# Access Compliance Report

## Public Rights-of-Way

Intersection ID: 23200	Main Street: MORROWICK_RD	Cross Street: RILEY'S RIDGE_RD	Location:	N
ADA ID: BC73C5DC5884	Ramp Type: PerpDiag	Initial Pass/Fail: Fail	Overall Compliance: No	Severity Score: 22.5

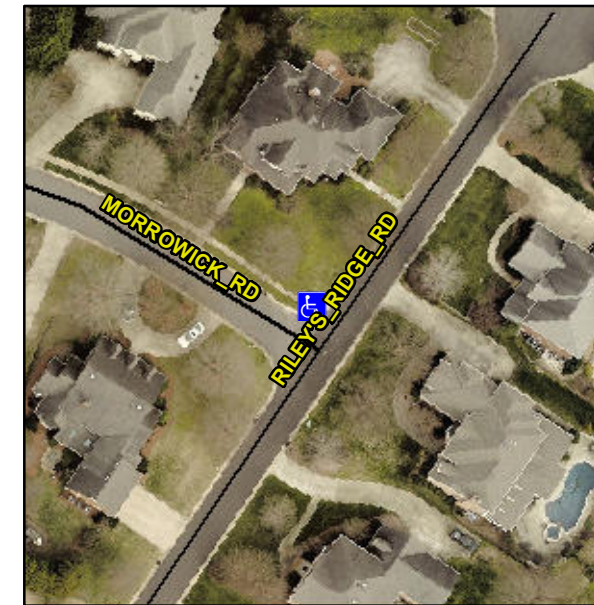
**Not Found, R304.5.1, R304.2.2, R304.5.3**

Compliance	Description	Data	Compliance	Description	Data
N/A	Ramp Length (in)	51.0	No	Ramp Slope (%)	8.7
No	Ramp Width (in)	36.0	No	Ramp XSlope (%)	4.2
N/A	Flare Type LT	N/A	N/A	Flare Type RT	N/A
N/A	Flare Slope LT (%)	N/A	N/A	Flare Slope RT (%)	N/A
N/A	Flare Traversable LT?	N/A	N/A	Flare Traversable RT?	N/A
N/A	Landing Length (in)	N/A	N/A	DWS Provided?	N/A
N/A	Landing Width (in)	N/A	N/A	DWS Contrast?	N/A
N/A	Landing Slope (%)	N/A	N/A	DWS Length (in)	N/A
N/A	Landing X Slope (%)	N/A	N/A	DWS Full Width?	N/A
N/A	Landing Curb? (Y/N)	N/A	N/A	DWS Offset (in)	N/A
N/A	Shared Landing?	N/A			
N/A	Gutter Ponding?	N/A	N/A	Gutter Slope (%)	N/A
N/A	Gutter Lip Ht (in)	N/A	N/A	Gutter X Slope (%)	N/A
N/A	Painted X Walk1?	No	N/A	Painted X Walk2?	No
	X Walk 1 Direction	To SW		X Walk 2 Direction	To SE
N/A	X Walk 1 Width (in)	N/A	N/A	X Walk 2 Width (in)	N/A
	X Walk 1 Slope (%)	1.9		X Walk 2 Slope (%)	1.0
	X Walk 1 X Slope (%)	0.7		X Walk 2 X Slope (%)	0.9

**Remove & Replace Curb Ramp With Two New Directional Ramps or Equivalent.**
